ADDENDUM NO. 3

TO: PLANS AND SPECIFICATIONS FOR THE STATE OF MISSOURI

Replace Fire Alarm Systems - Multiple Assets
Western Reception and Diagnostic Correctional Center
St. Joseph, Missouri
PROJECT No.: C2325-01

1 MAINTENANCE BUILDING - FIRST FLOOR FIRE ALARM PLAN
SCALE: 3/32" = 1'-0"

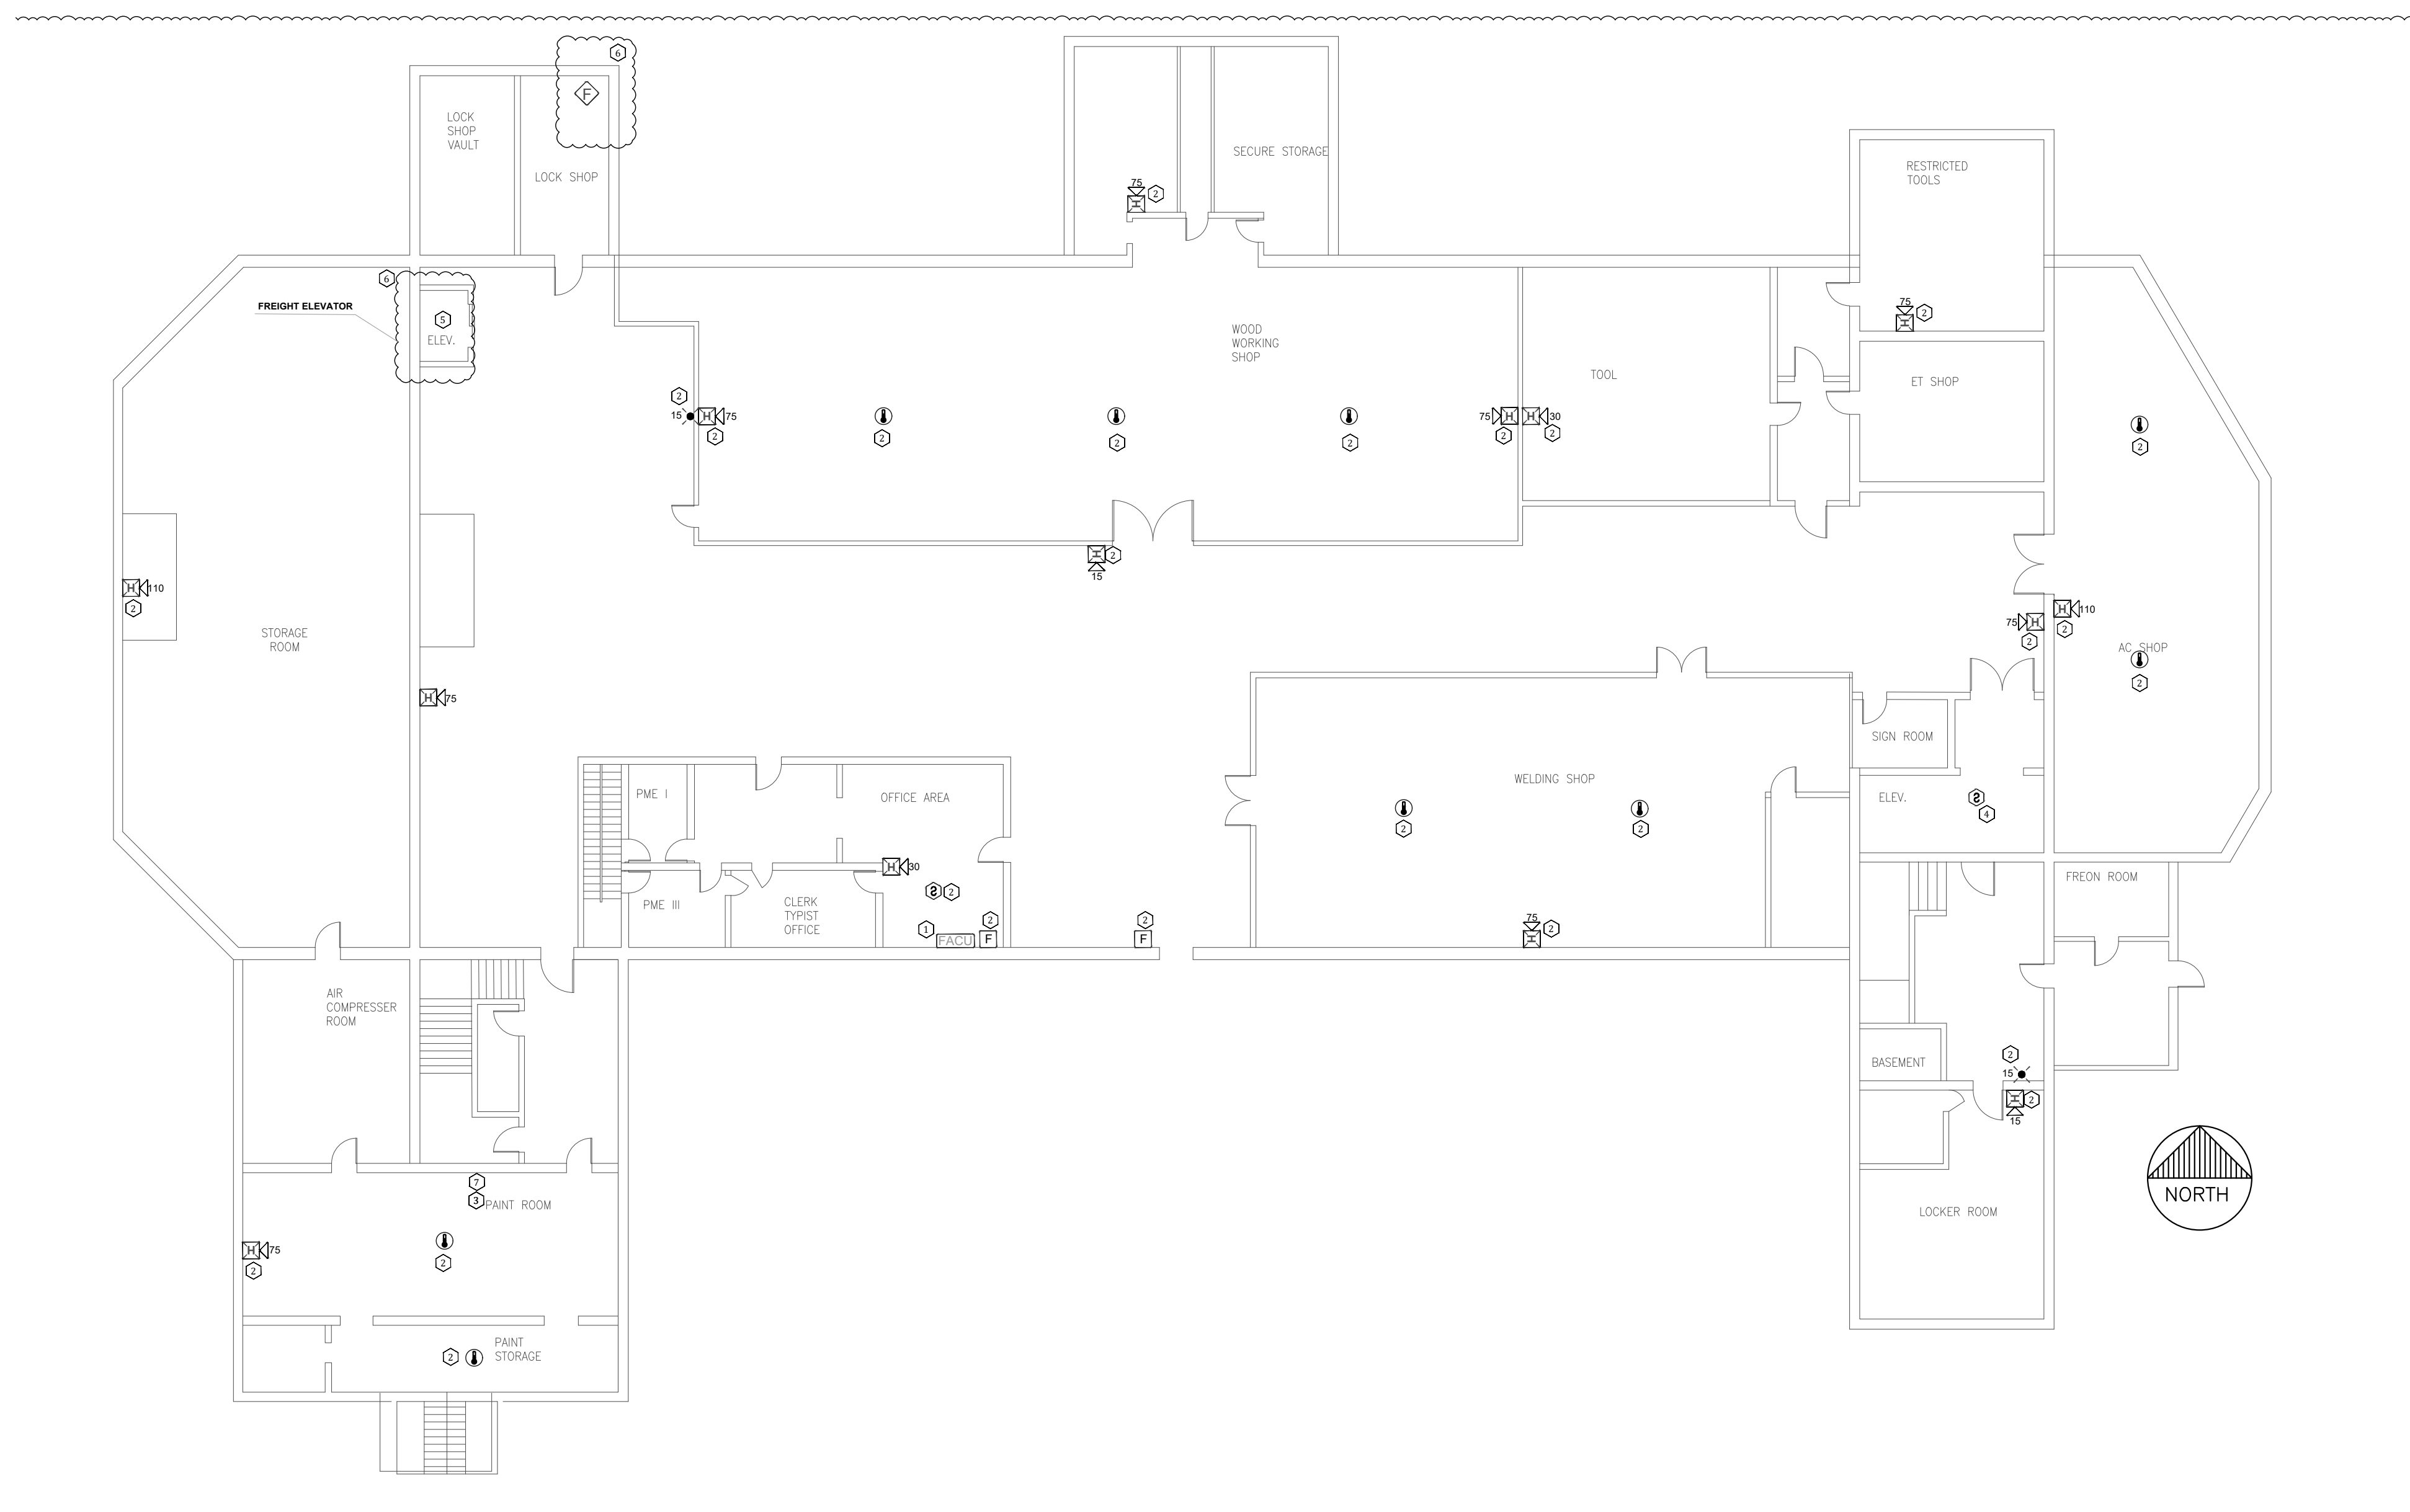
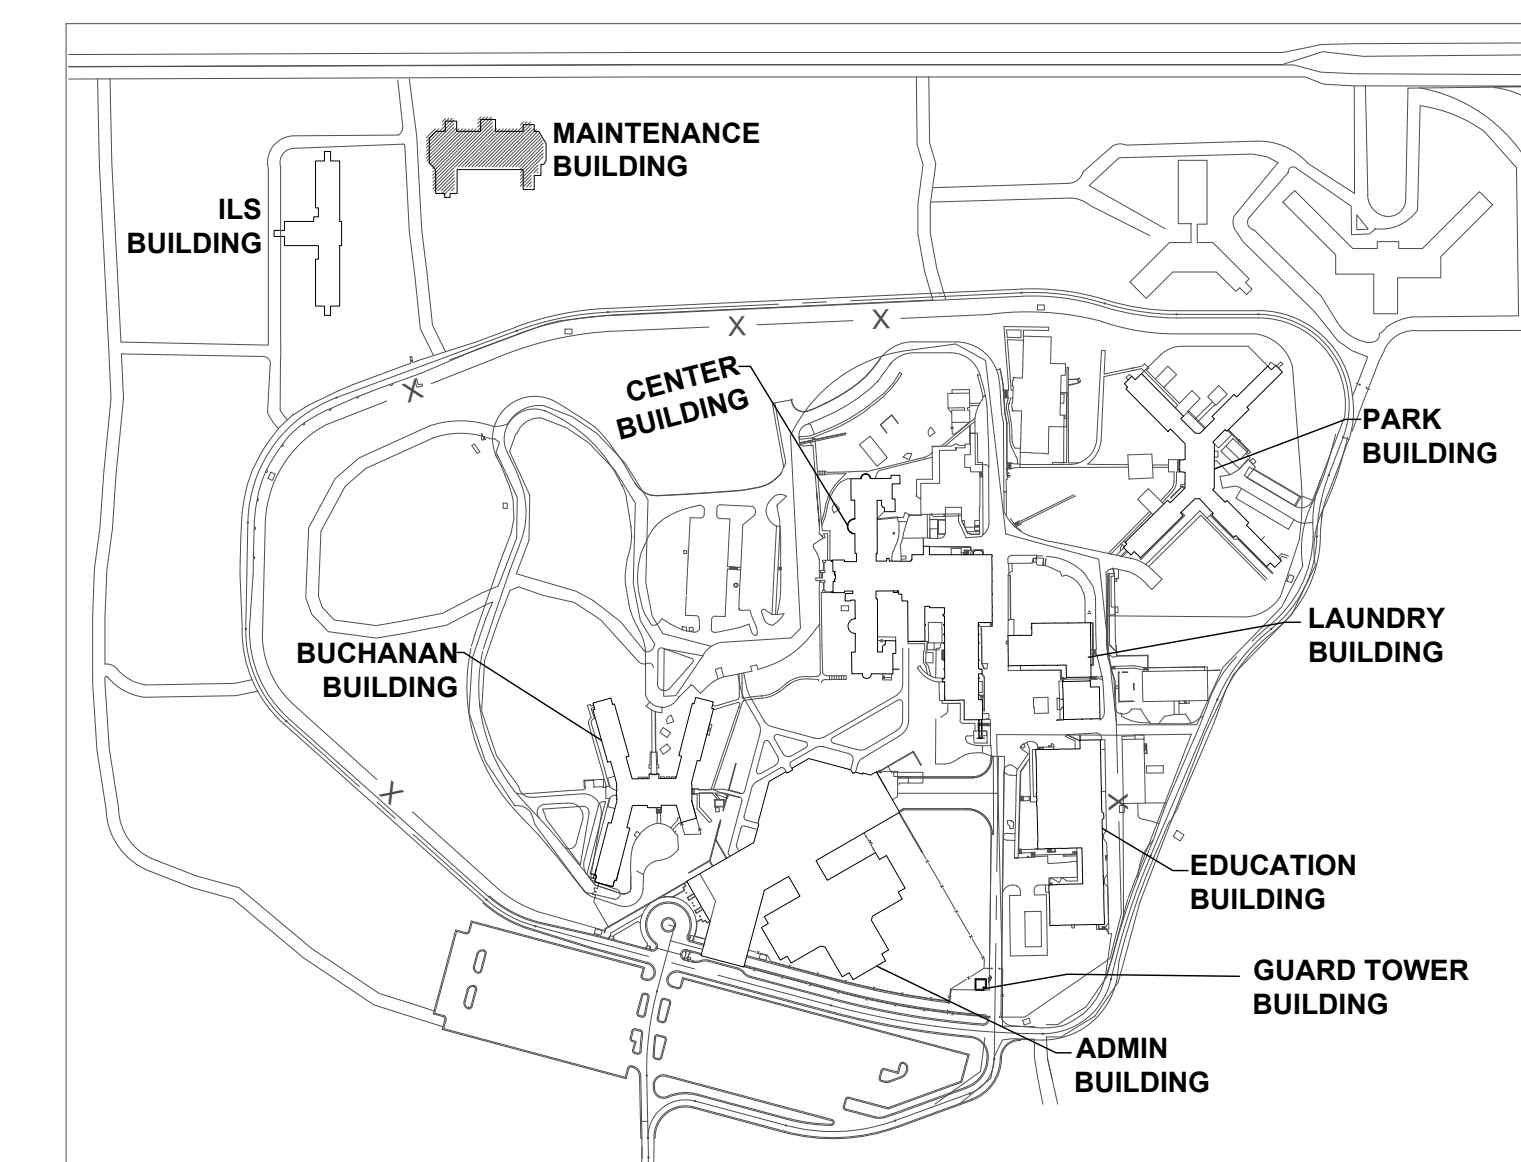
- b. REVISED Elevator label and smoke detection for elevator recall and Keynote.
 - c. See attached revised drawing.
- 13. Sheet FA501
 - a. REVISED Notification and detection layout and Sprinkler monitoring equipment.

- b. ADDED Crawl space floor plan.
 - c. See attached revised drawing.
- 14. Sheets FA600, FA601-1, FA601-2, FA602-1, FA602-2, FA603-1, FA603-2, FA604-1, FA604-2

1 PARK BUILDING - FIRST FLOOR FIRE ALARM PLAN
SCALE: 3/32" = 1'-0" NORTH

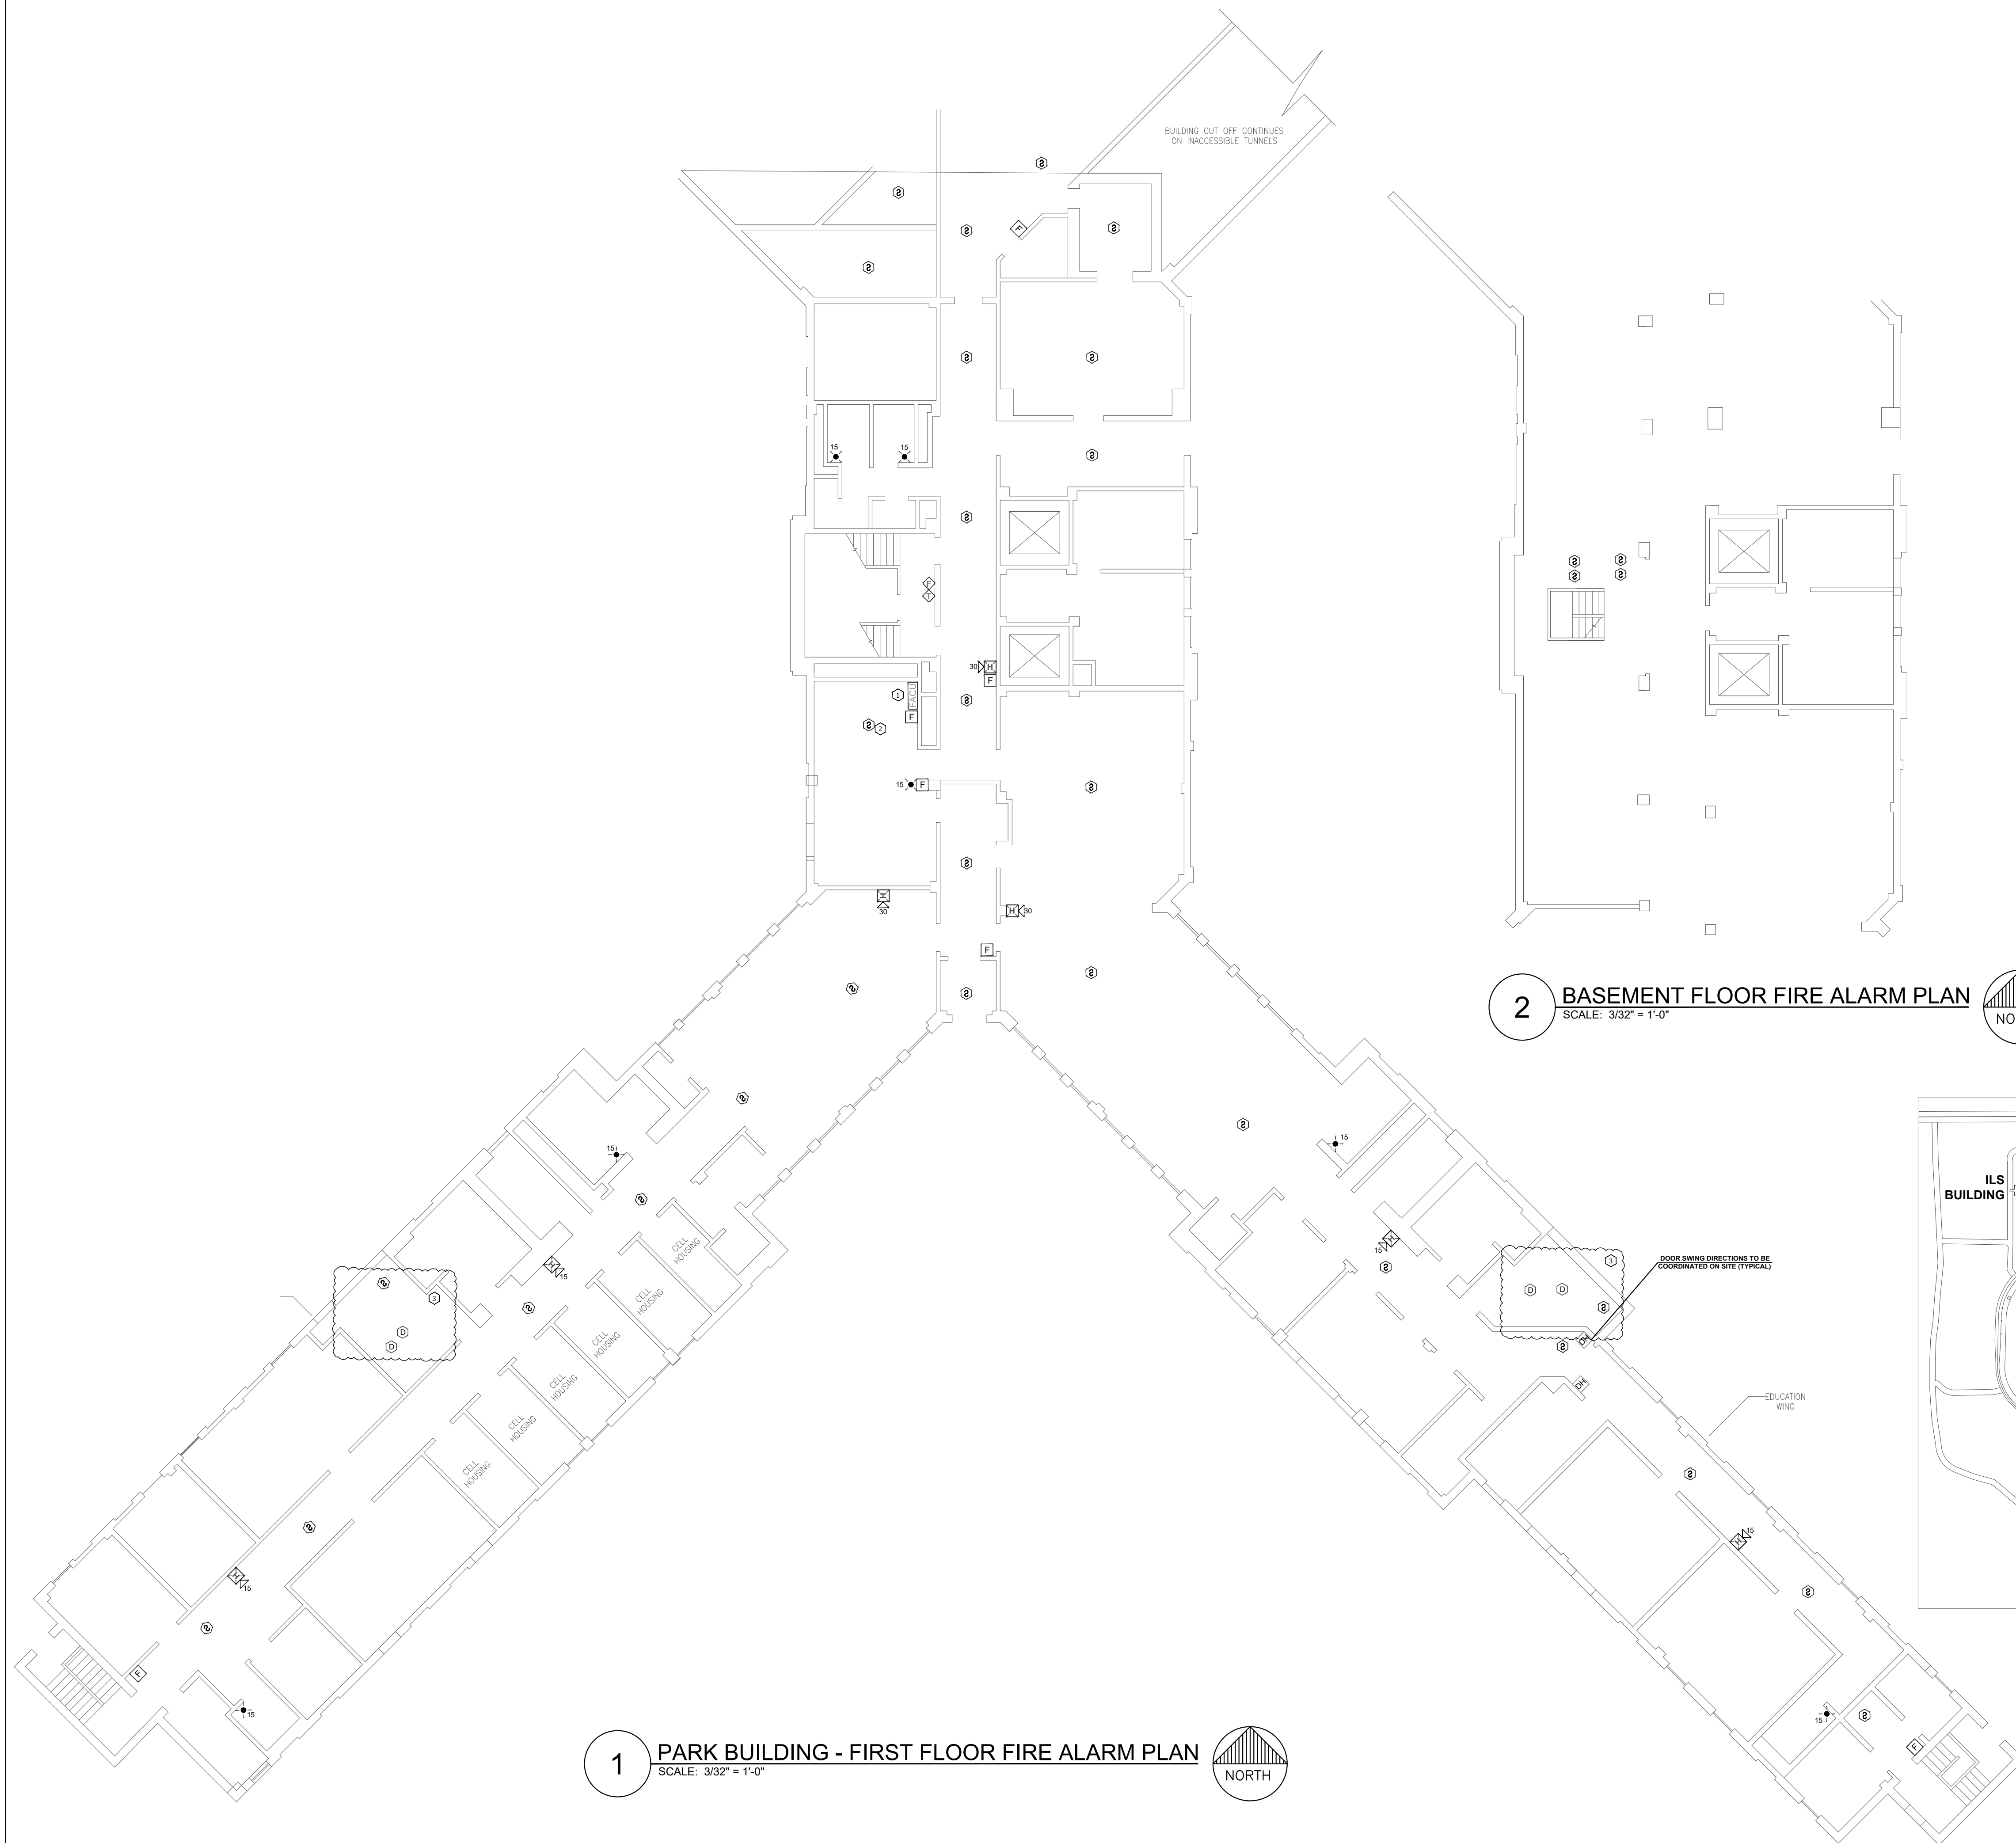
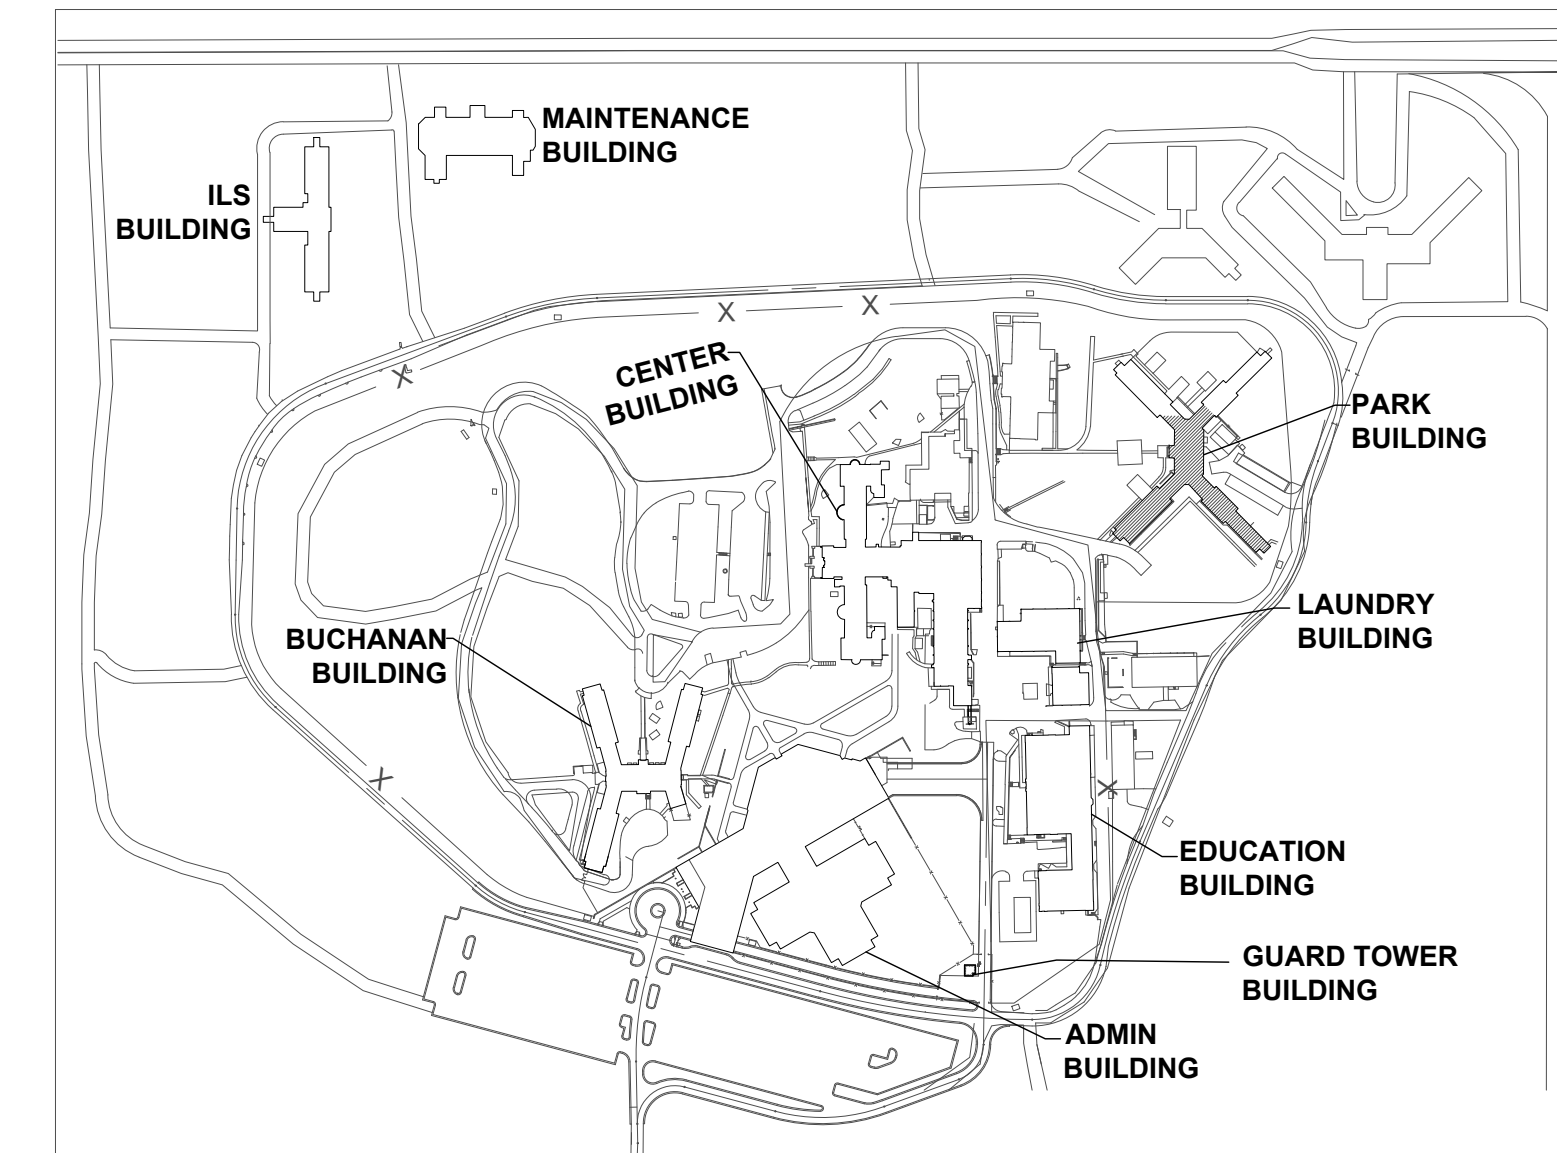
- a. ADDED General notes set.

- b. REVISED Mechanical room smoke and duct detection and Smoke detection in residential halls.
 - c. See attached revised drawings.
15. Sheets FA800 and FA801
- a. REVISED Floor Plan, Notification provided, and Sprinkler monitoring equipment.
 - b. See attached revised drawings.
16. Sheet FAD100-3
- a. ADDED Existing conditions detail from as-builts.
 - b. See attached revised drawing.
